SKA-052

Re: Architect's Certification for Permanent C.O.
Heart Institute Medical Office Building
502 Elm Street
Albuquerque, NM 87102
Case No. 1000596

SECOND AMENDED SITE PLAN FOR SUBDIVISION
 Proposal for new Tract 2B1

HEART INSTITUTE MEDICAL OFFICE BUILDING

REVISED PARKING LAYOUT

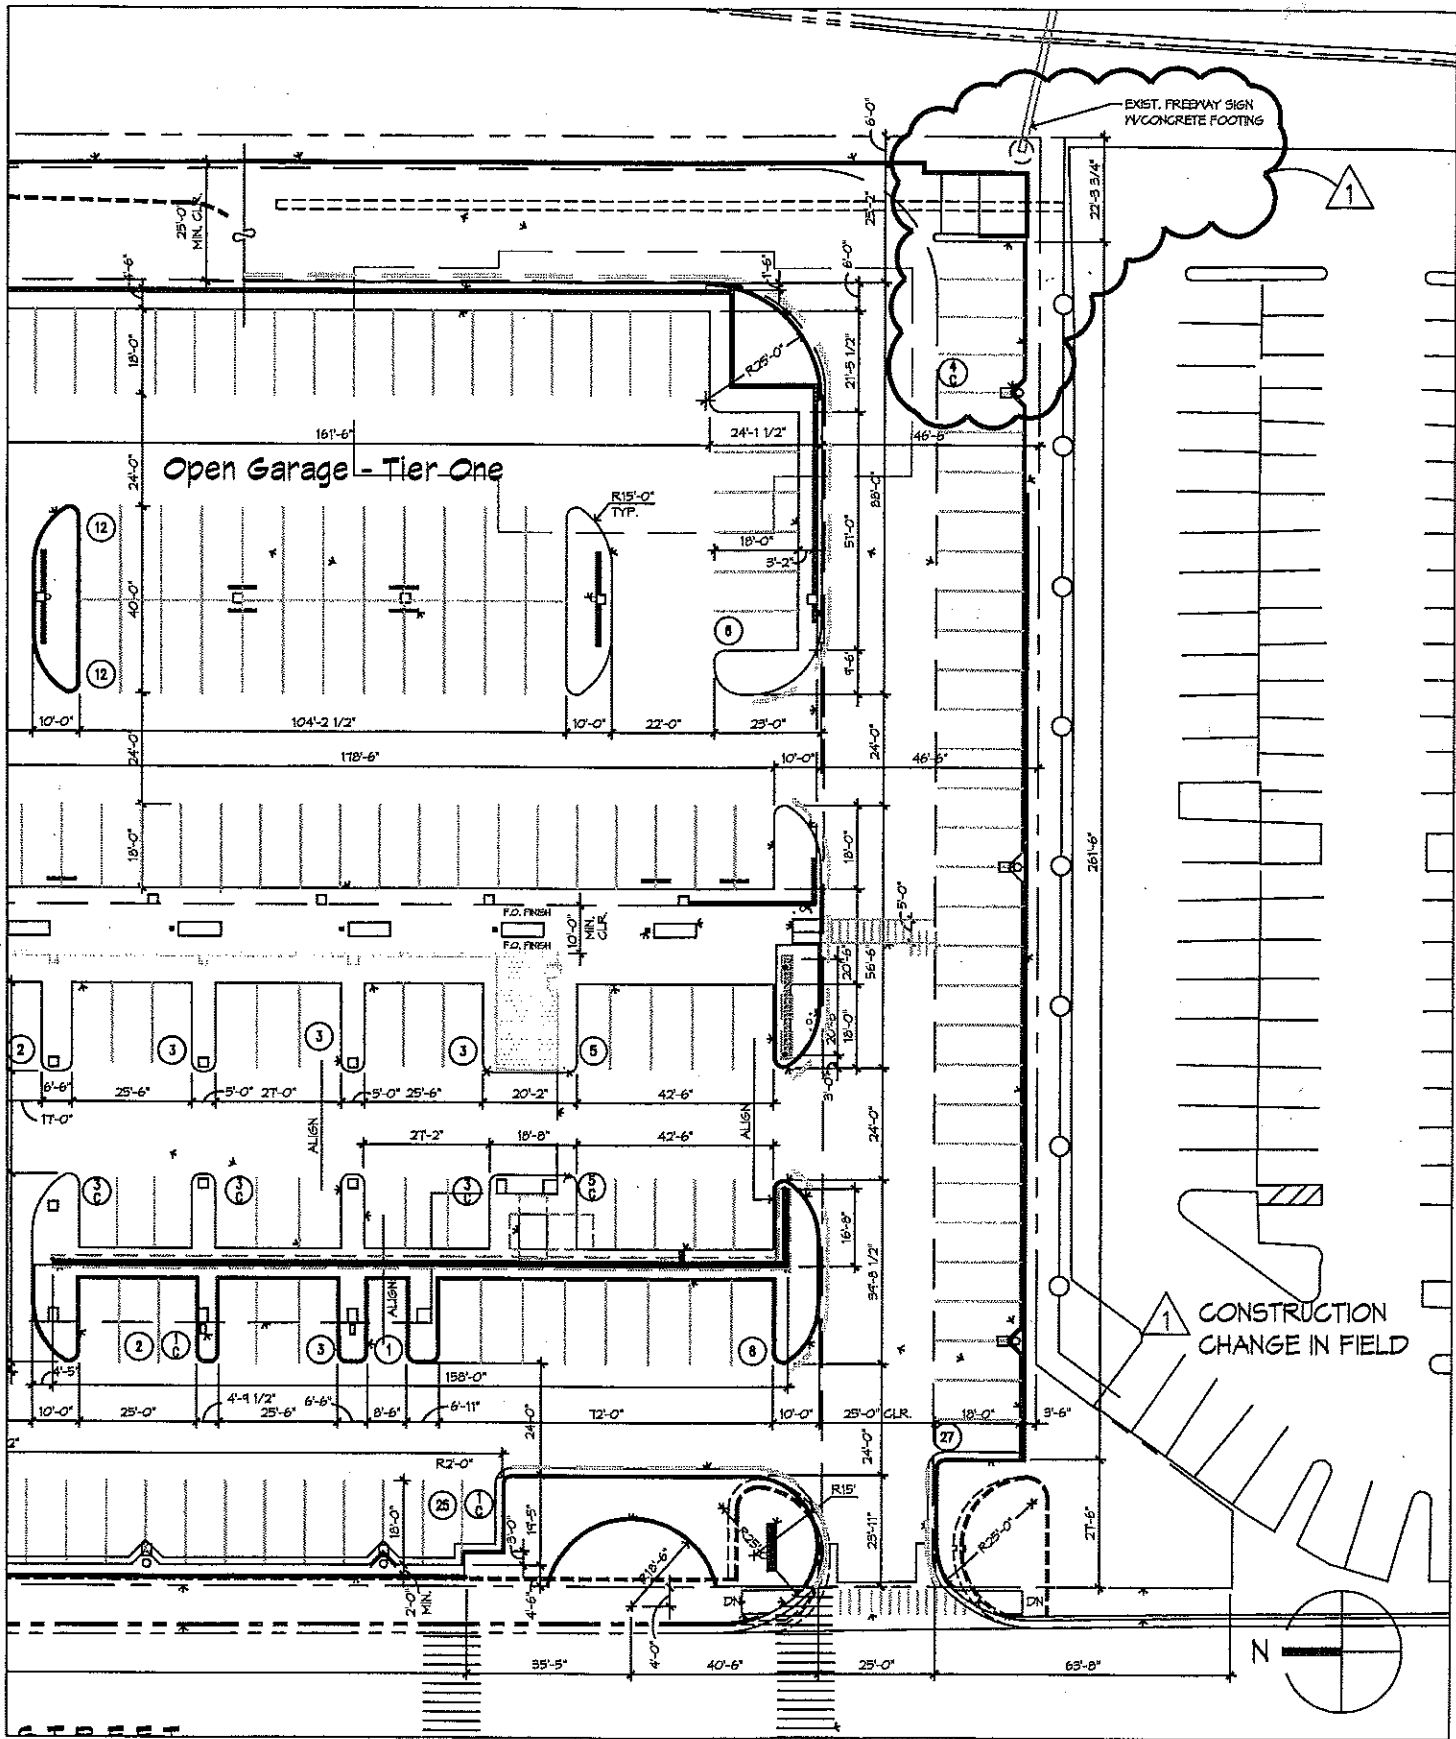
1. Trash Enclosure relocation:
The trash enclosure was moved 2'-0" west to avoid undermining the concrete footing of an existing overhead highway sign. As a result, four parking stalls were stripped as compact stalls instead of standard stalls. This change increased our total from 45 compact stalls to 49. Our maximum allowable is 66 compact stalls. (see enclosures)
2. Height of ADA signage:
We have pole-mounted signage in the public way. As per ADA the signage was designed to be mounted at 5'-0" above finish grade. However, the signage was mounted at 7'-0" above finish grade due to a stipulation in the Manual of Uniform Traffic Control Devices, which allows for signage in the public way to be mounted at 7'-0", to avoid injury to pedestrians. (see enclosures)
